95.7.2 100GBASE-SR4 receive optical specifications

(Note to reader: red, green and purple and yellow highlighting show text of interest, teal and magenta show insertions and deletions)

95.8.8 Stressed receiver sensitivity

Figure 95-5—Stressed receiver conformance test block diagram

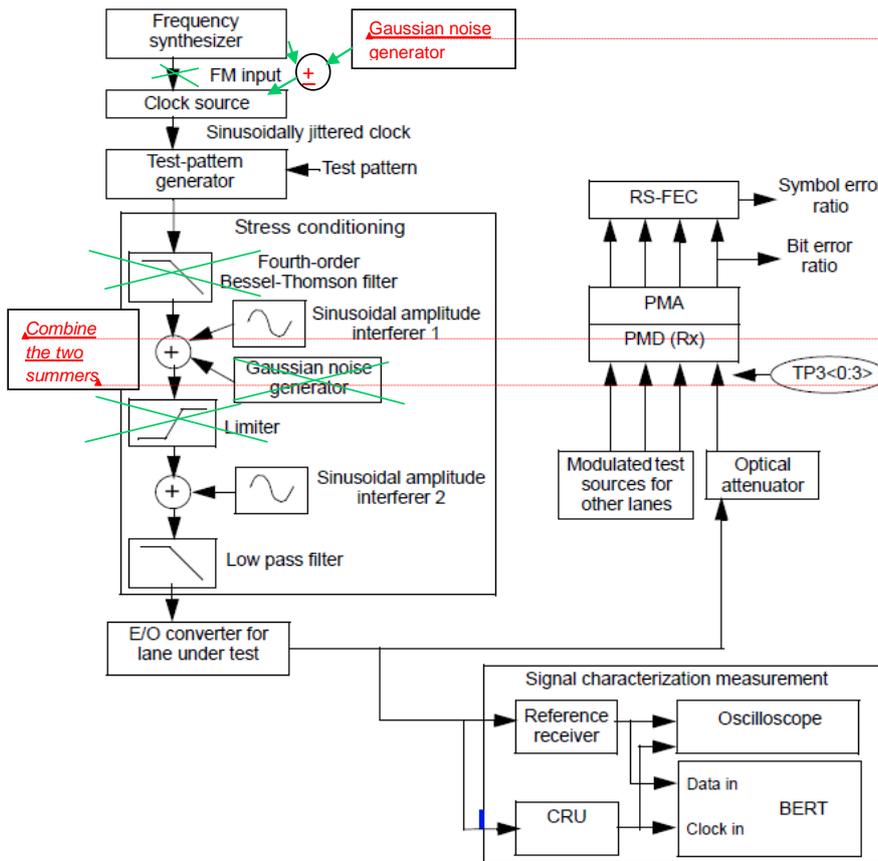
Comment [PD1]: Name of the test, and test block diagram, underlined in green. 5 instances should be consistent (one or two terms). Comment r02-21.

Comment [PD6]: Which of the two fourth-order Bessel-Thomson filters? Comment r02-22.

Comment [PD7]: Which is what? Comments r02-23, r02-32

Comment [PD8]: This is repeated later. Comment r02-29.

Comment [PD9]: If the SJ is swept, is it reasonable to avoid a harmonic relationship between it and all those other things? OTOH, one probably should when calibrating.
